**ADDENDUM NO. 2
July 6, 2023**

**Taxiway A Reconstruction – Phase 3
Duluth International Airport (DLH)
Duluth, Minnesota
City of Duluth No. 23-4409
AIP No. 3-27-0024-074-2022
SP No. A6901-205
SEH No. DULAI 168804**

From: Short Elliott Hendrickson Inc.
3535 Vadnais Center Drive
St. Paul, MN 55110-3507
651.490.2000

SHEET
E-101

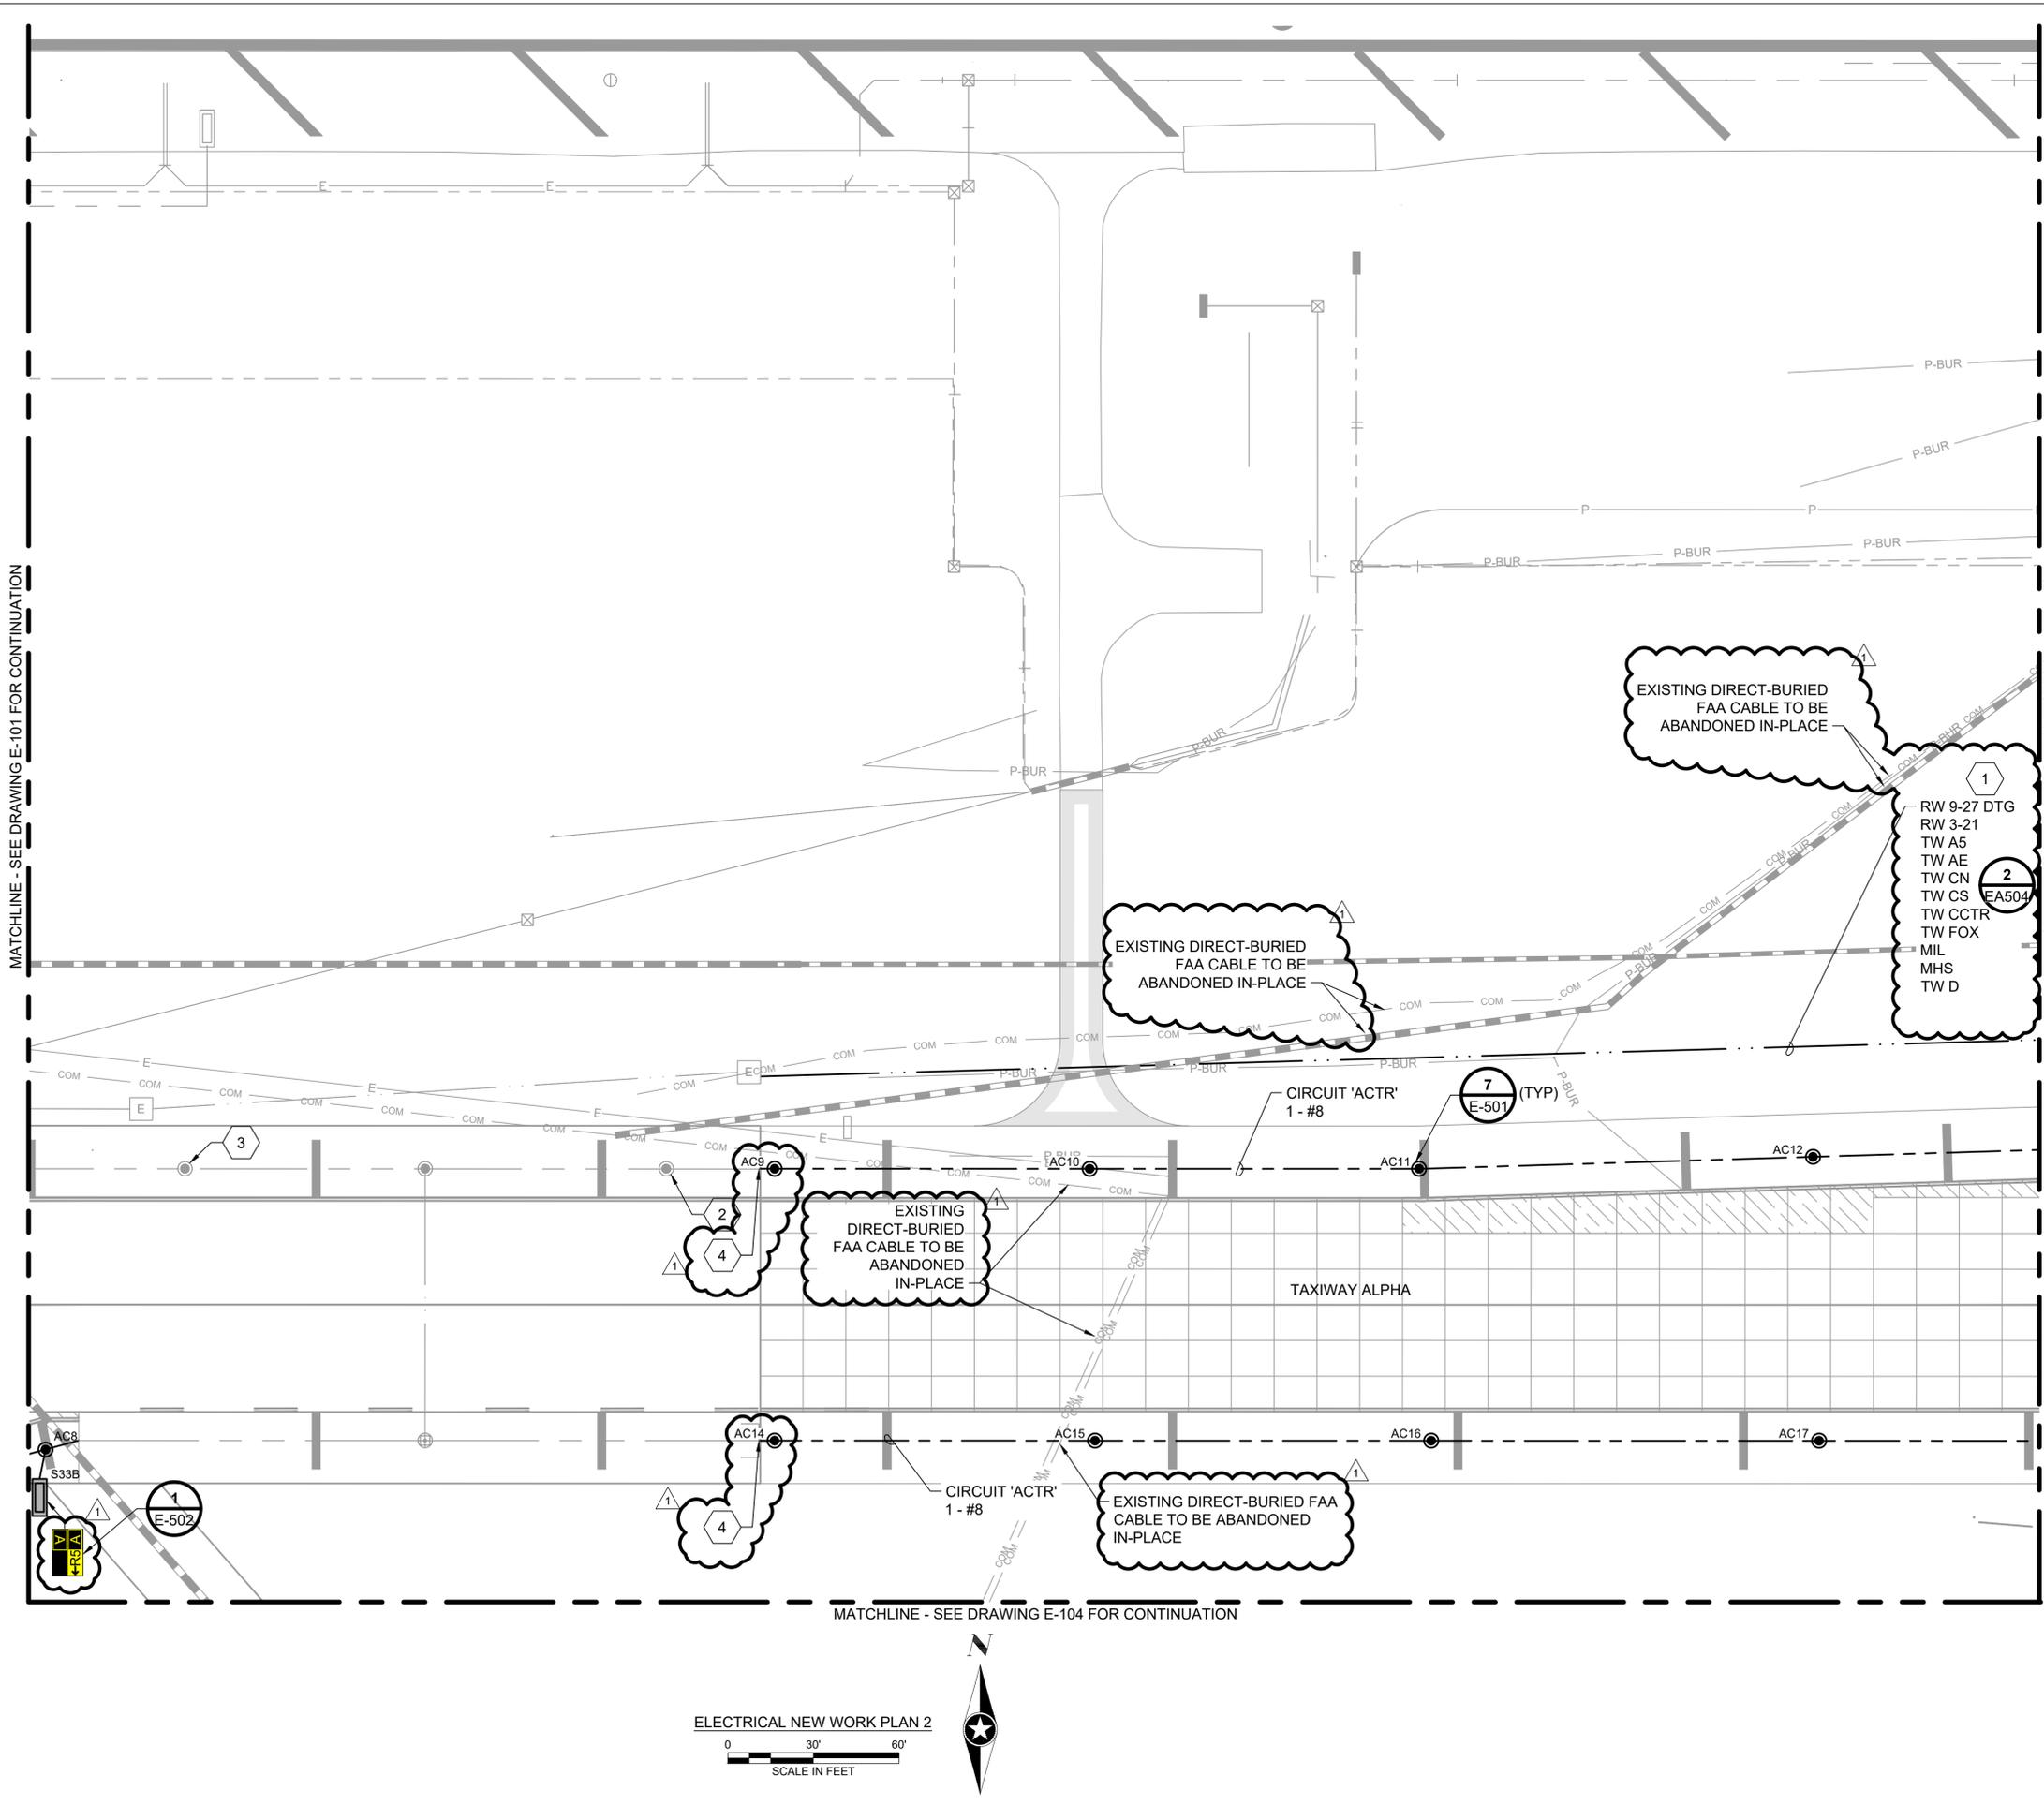
11. Drawing E-101 Electrical New Work Plan 1 – Updated sign faces along what is now identified as Taxiway Romeo 5. DELETE in its entirety and REPLACE with the attached revised drawing.

SHEET
E-102

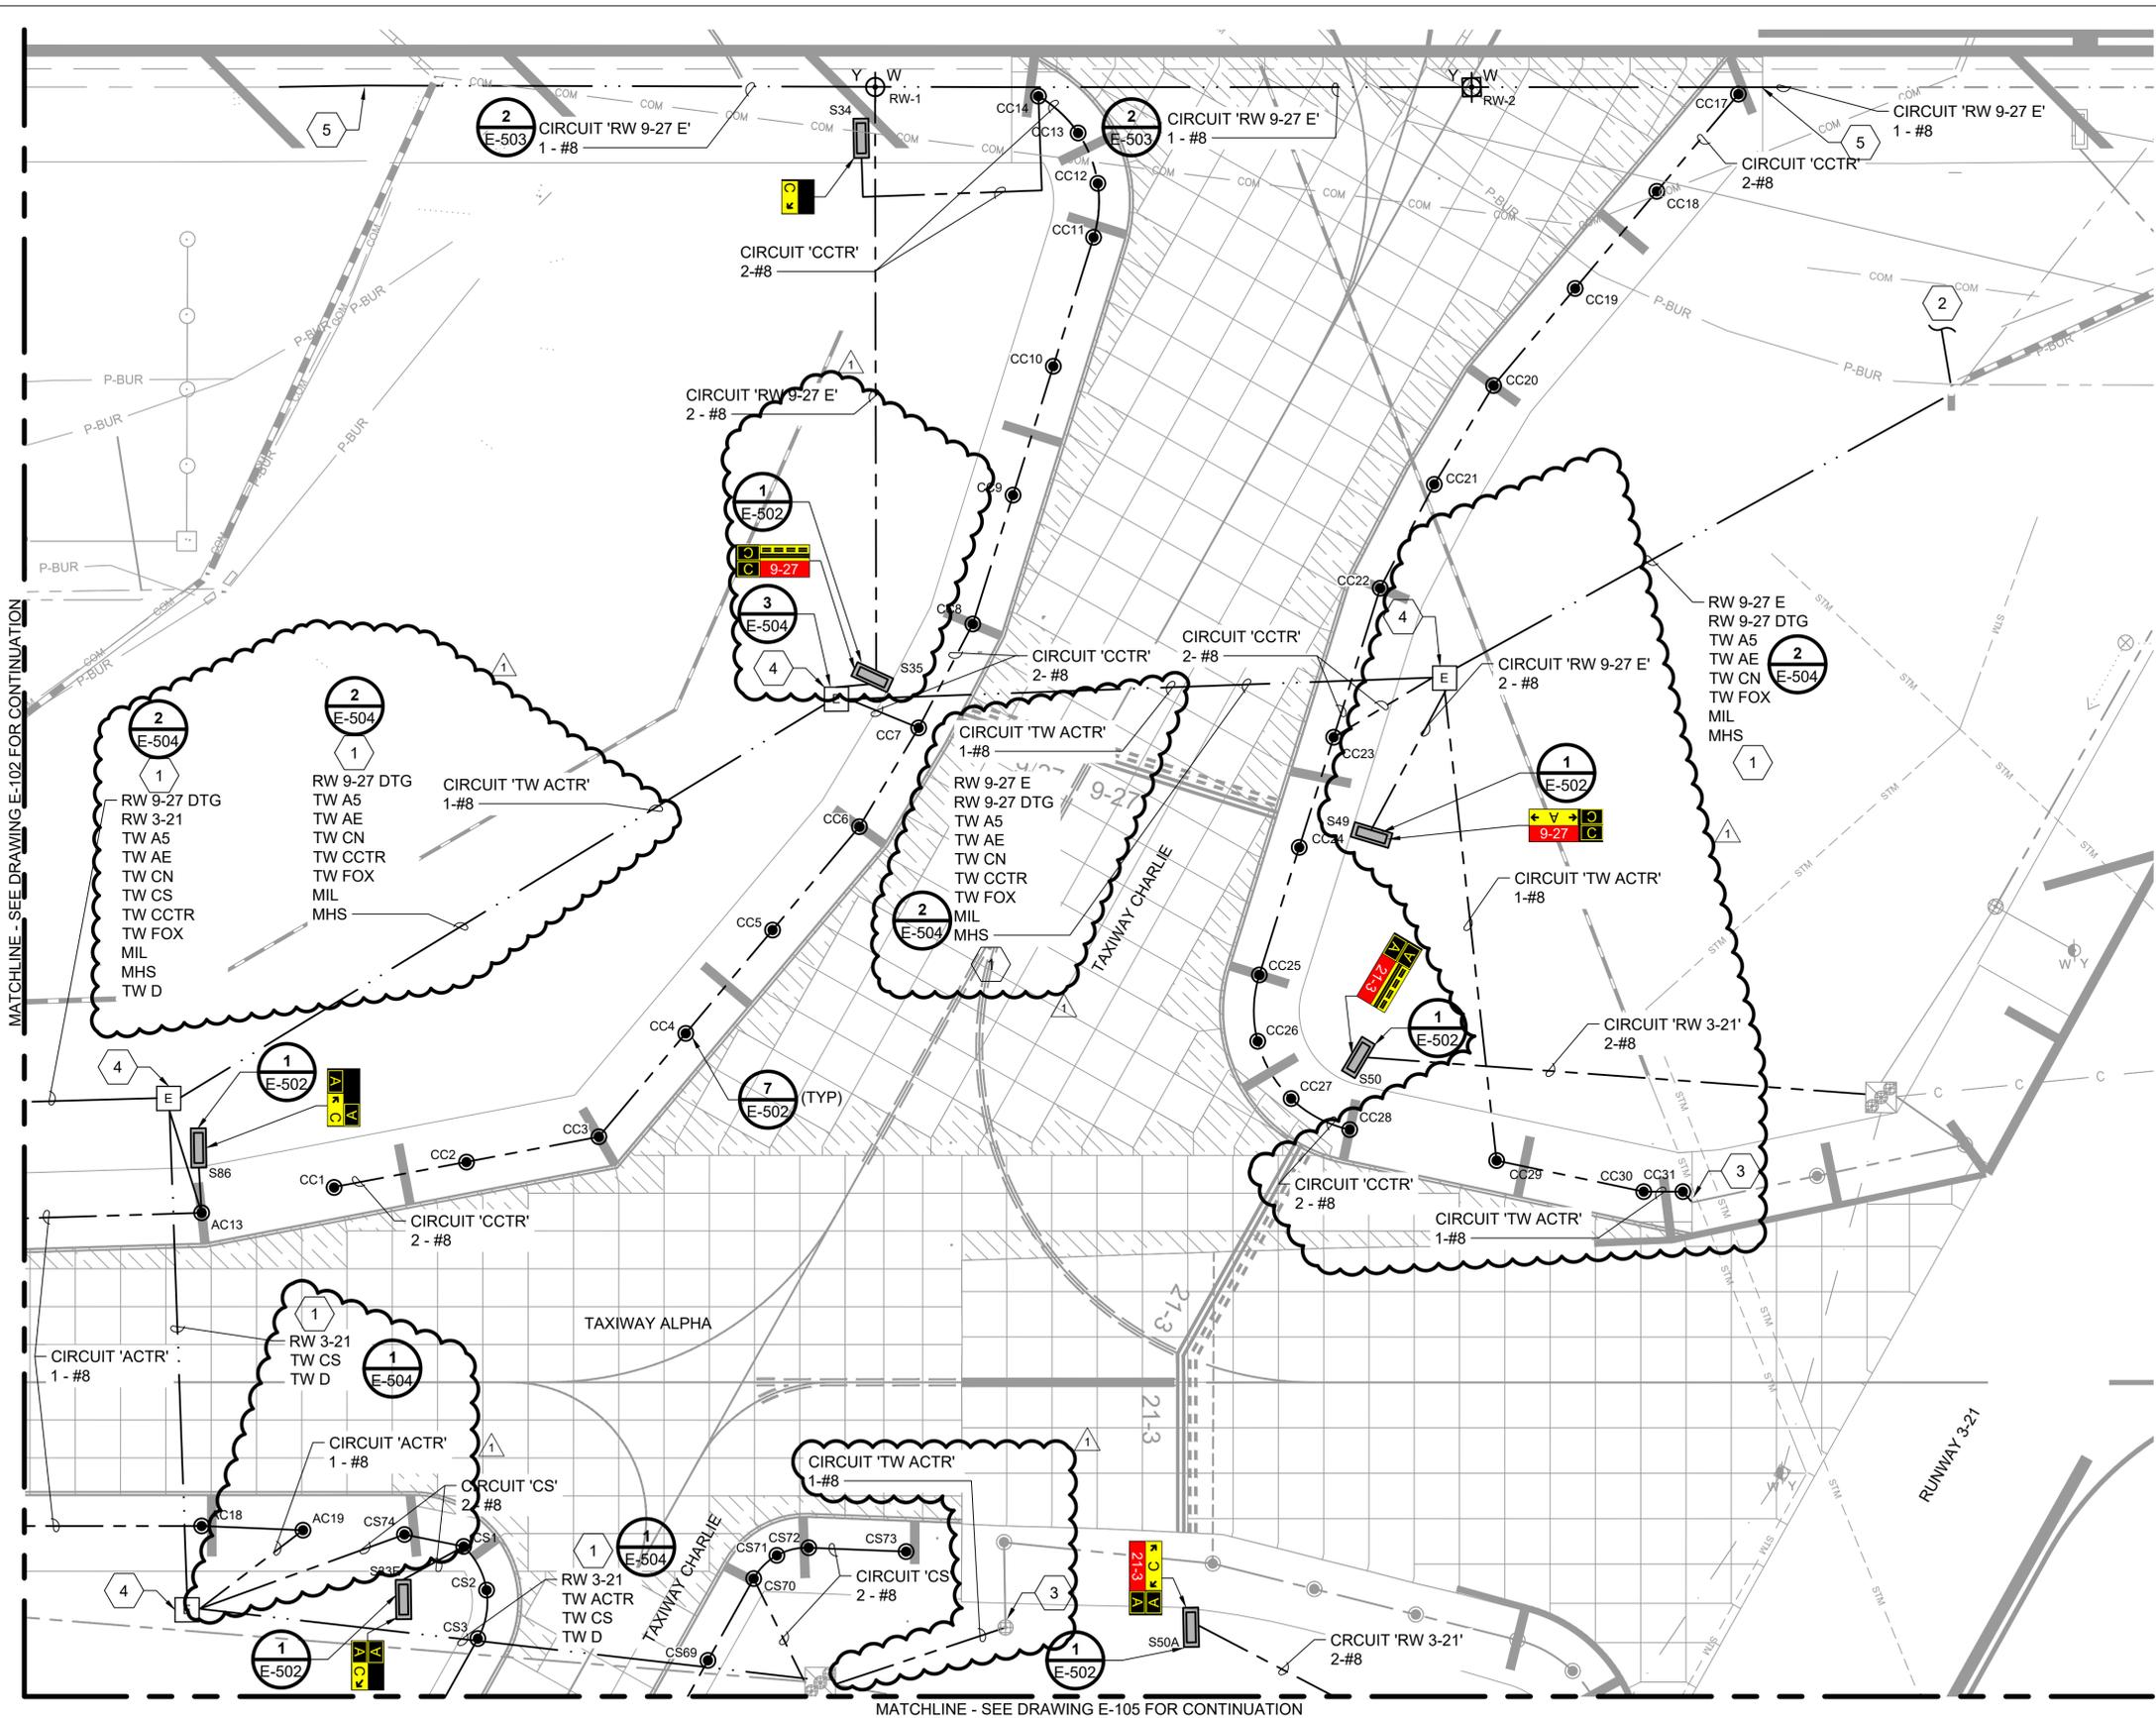
12. Drawing E-102 Electrical New Work Plan 2 – Updated circuitry notes included for circuit TW ACTR. Updated notes for existing FAA ductbank. Plan reflects revised locations for lights AC9 and AC14. Keyed note 4 added for clarification to required cable splicing. Updated sign face along what is now identified as Taxiway Romeo 5. DELETE in its entirety and REPLACE with the attached revised drawing.

SHEET
E-103

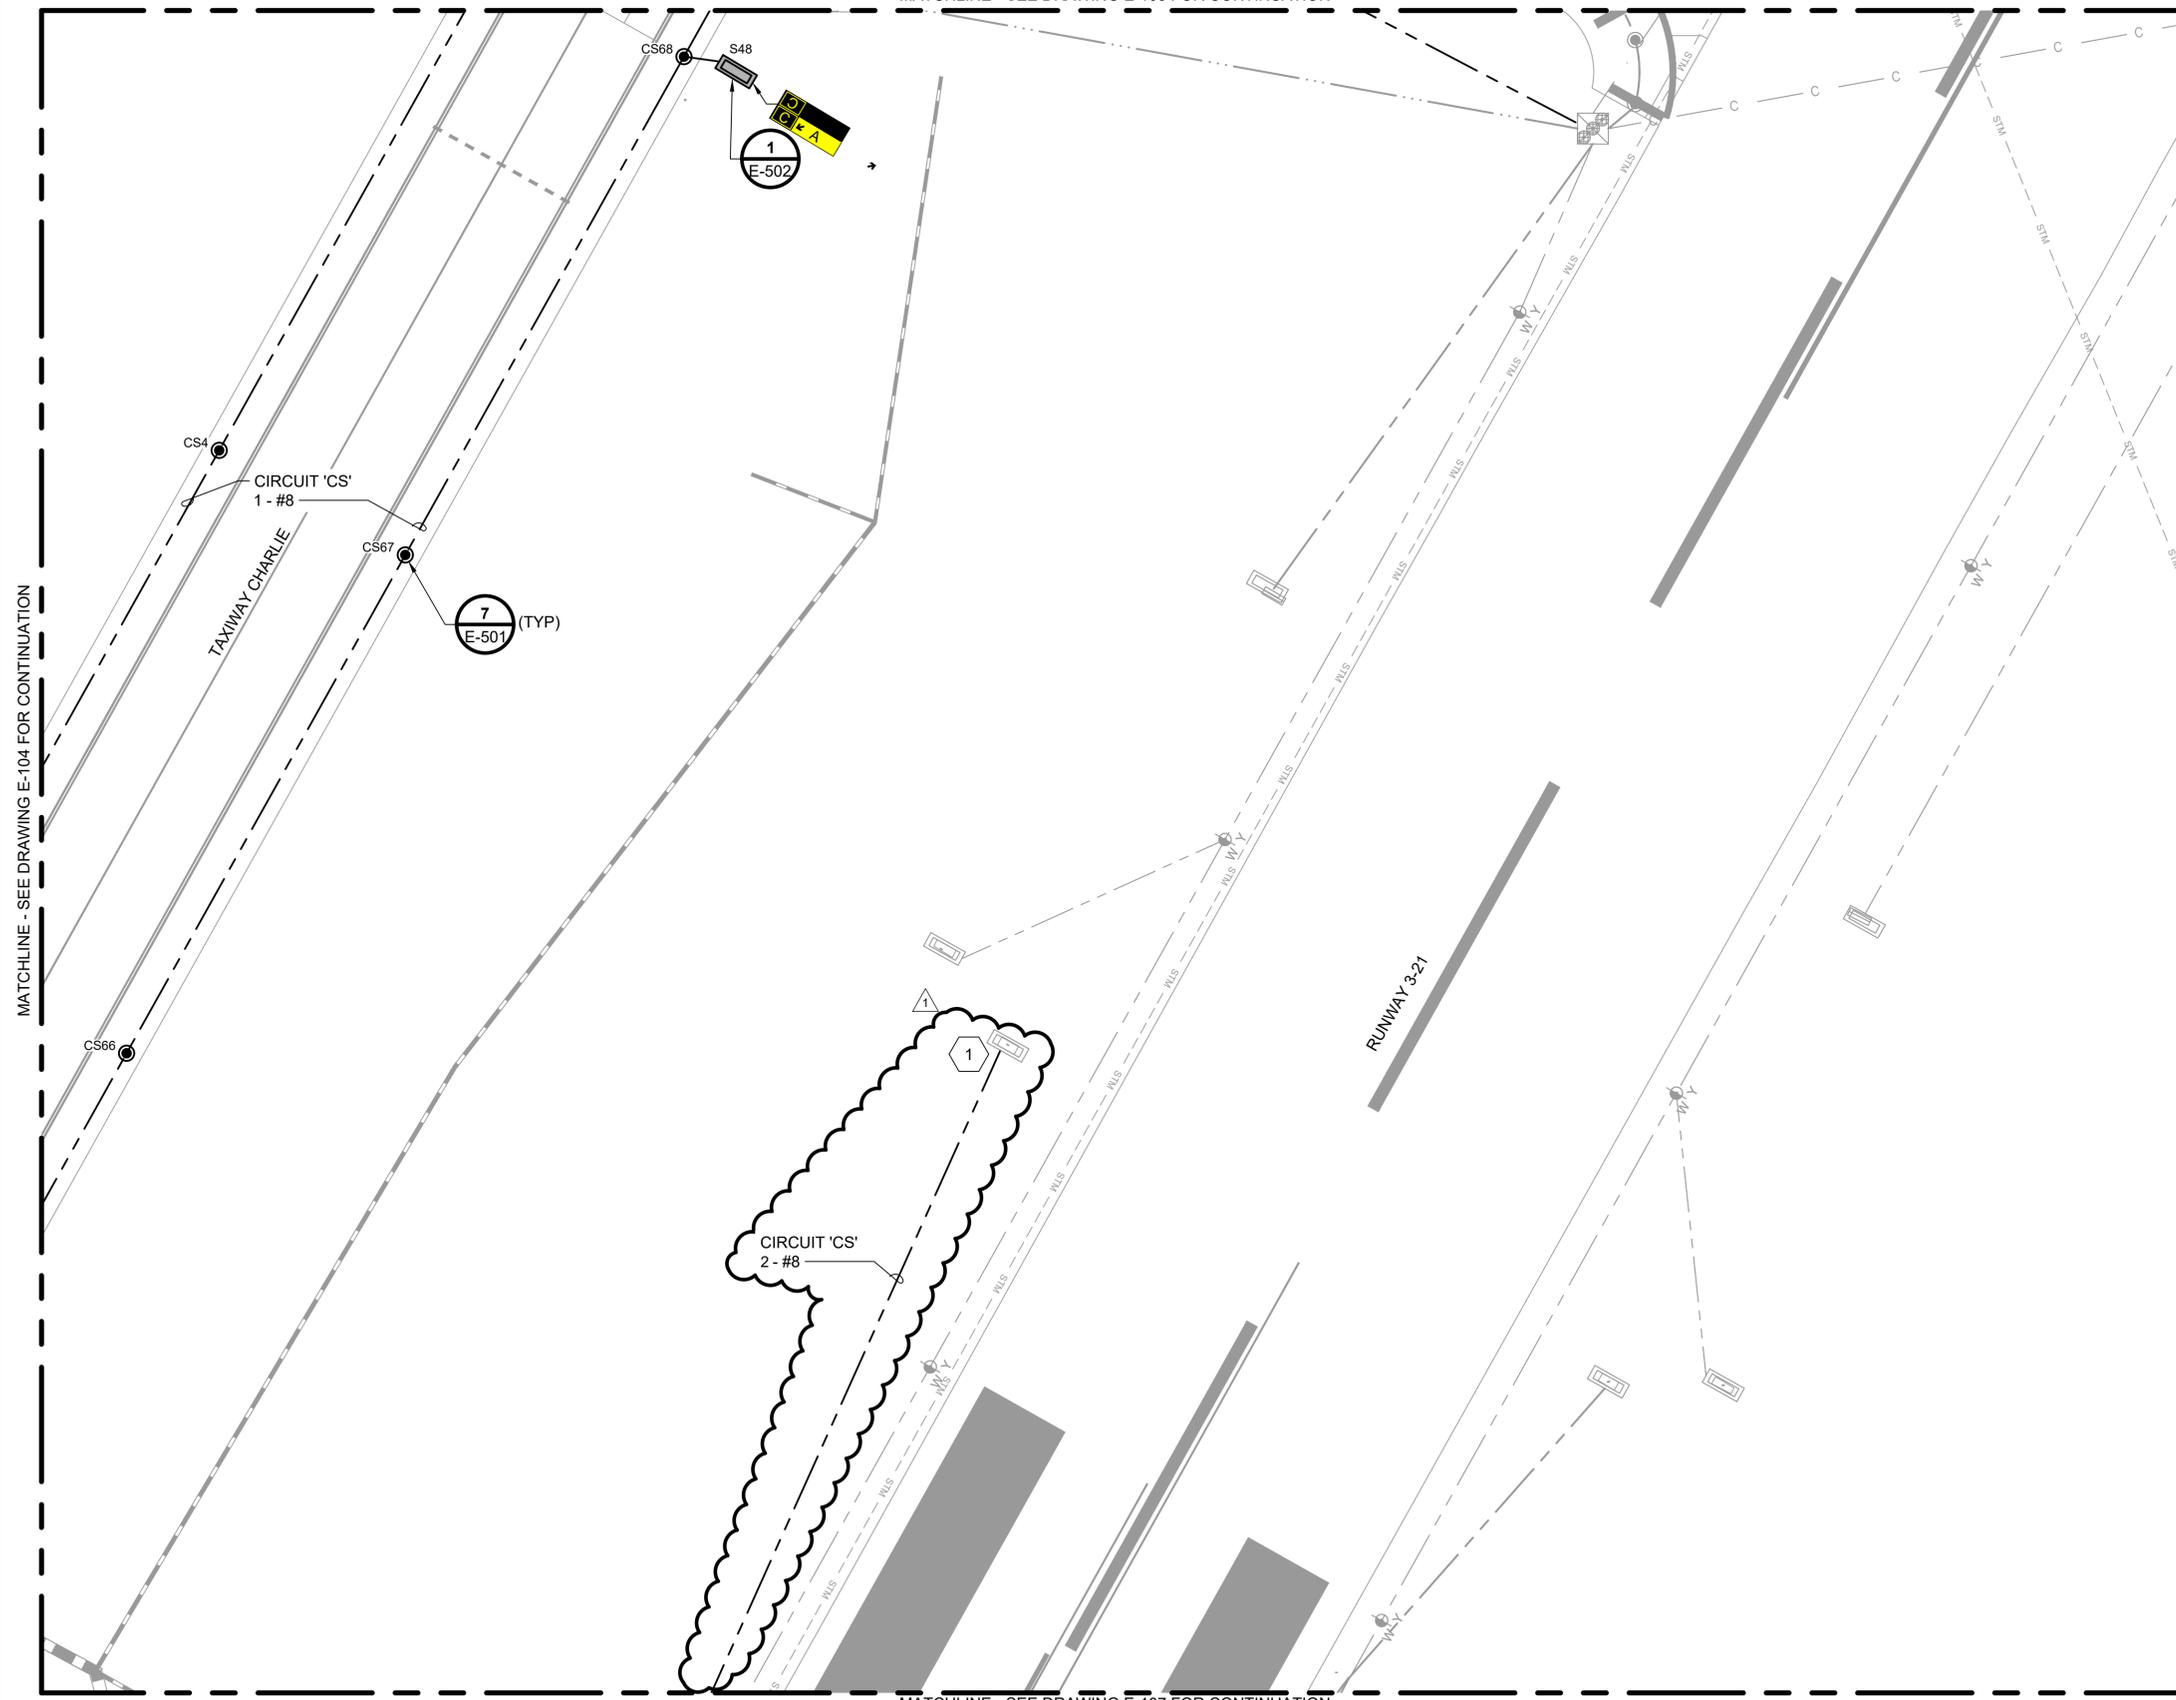
13. Drawing E-103 Electrical New Work Plan 3 – Updated circuitry loop is reflected for circuit TW ACTR, and installation of (2) additional light fixtures is reflected. Revised where circuit TW ACTR enters first light fixture along TW Alpha, updating light fixture AC20 to now be labeled as CS74. Sign faces for airfield signs S35 and S49 are revised. DELETE in its entirety and REPLACE with the attached revised drawing.
